Item 10.**Development Application: 220 Victoria Street, Beaconsfield**

File No.: D/2017/1754

Summary**Date of Submission:** 15 December 2017

Figure 16: The proposed development in the context of the height of the adjacent developments

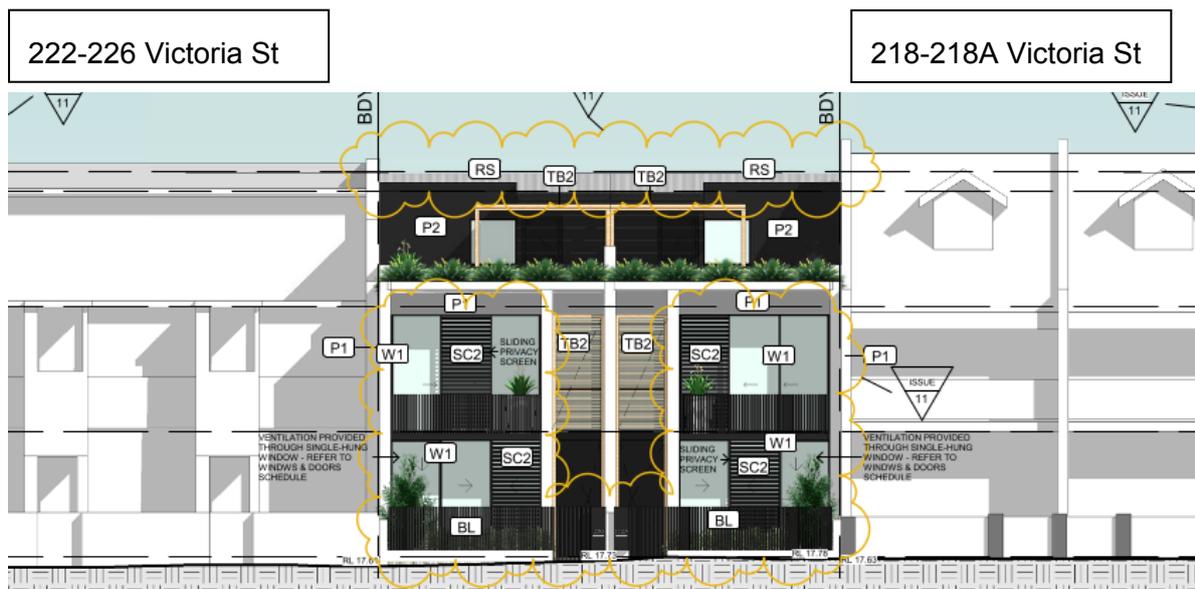
30. Figure 16, below, illustrates the height of the proposed development in relation to both its immediately adjoining neighbours at 218-218A Victoria Street and 222-226 Victoria Street.
31. The proposal has a skillion roof that pitches up from the front of the site. The roof has a lower gutter line of RL 26.09 and a ridge height of RL 27.03. The proposed ridge height is lower than that of the neighbouring 2-storey neighbouring at Nos. 218 and 218A Victoria Street (RL 27.61) and the neighbouring 3-storey group at Nos. 222-226 Victoria Street (RL 27.25).

32. Considering the existing and future character of this area of Beaconsfield, it is considered that a three-storey development of this built form is not out of character and can be considered contextually appropriate in this instance. The skillion roof was amended to a pitched roof to reduce the visual prominence of the second floor when viewed from the west (rear). Furthermore, as detailed in this report, the second floor has been adequately setback from the street to lessen its visual presence and bulk.

33. Notwithstanding that the additional storey can be supported, a design modification condition is recommended for imposition requiring that:
 - (a) the second floor rear (western) elevation balconies accessed off the master bedrooms be deleted, as well as associated blade walls and retractable blinds. Further discussion on the recommendation to delete these balconies is included below under the heading "balconies"; and

- (b) the proposed second storey 'Colorbond' facade treatment be provided to the side and rear elevations where exposed in order to differentiate the second storey from the storeys below.
